NORTHEAST UTILITIES

Millstone Nuclear Power Station, Unit No. 3
Transmittal of Responses to Safety
Evaluation Report (SER) Confirmatory Items

Structural Audit Item 41 - (Item I from June 14 meeting with NRC)

Discussion of Stone & Webster Engineering Corporation's Missile Barrier Interaction Topical Report (SWEC-7703)

POWER INDUSTRY GROUP		TITLE NUSCO-MILLSTONE #3 TORNADO MISSILE BARRIER PANEL SIZES OF CAT I STRUCTS	SCALE: NO SCALE	
CHECKED			DATE: JUNE 26, 84	
CORRECT			SKETCH NUMBER	
APPROVED			PG 1	
REVISIONS	②	③	④	⑤

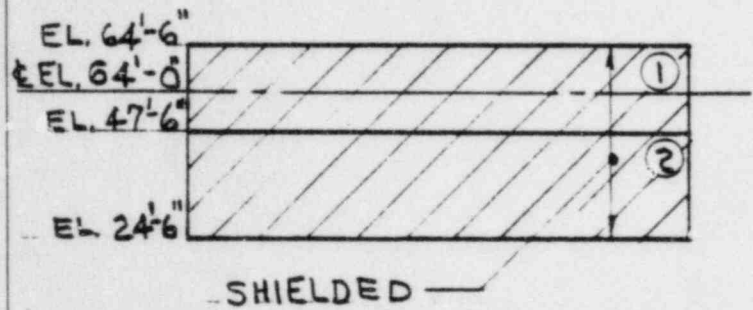
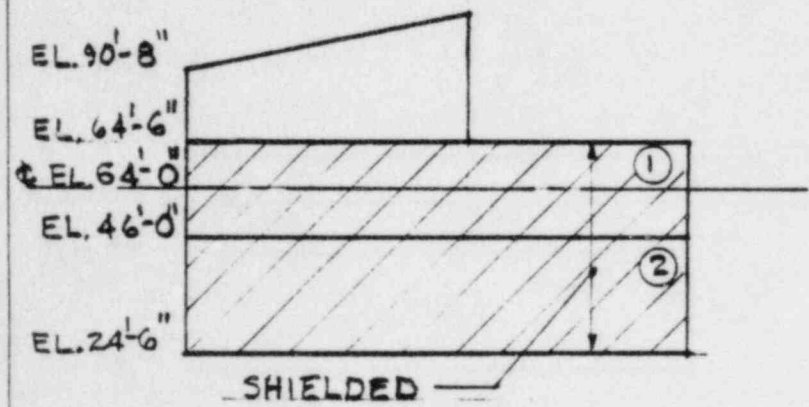
- A. Additional data is required to justify ductility ratio and impulse values for the auto impact study. The applicant will provide this information.
- B. Ductility Ratio - The applicant will (1) survey all Category I structures exterior walls above ground level and prepare a table of panel sizes, (2) identify any panels less than 24 in. thick and (3) identify the limiting panel size. If the limiting panel size should be less than 10' x 10', we will then look at the ductility ratio.

As requested, the applicant has performed a survey of all exterior wall panels to a height of 30 ft above grade which provide tornado missile protection. All walls providing protection from tornado missiles are a minimum 2 ft thick. The results of the survey are as indicated on the attached sheets. Those panels which provide missile protection, but are naturally shielded by other structures are so indicated. The results of the survey indicate that there is only one panel with a dimension less than 10 ft which would be subjected to impact by the automobile missile. However, this panel is shielded such that the automobile impacts close to the 2 ft roof support and the impact load is transferred directly into the roof. (G.6 Line Wall in Fuel Building. Page 7 of Attachment).

The results of the survey show the exterior walls are adequately protected against tornado missiles.
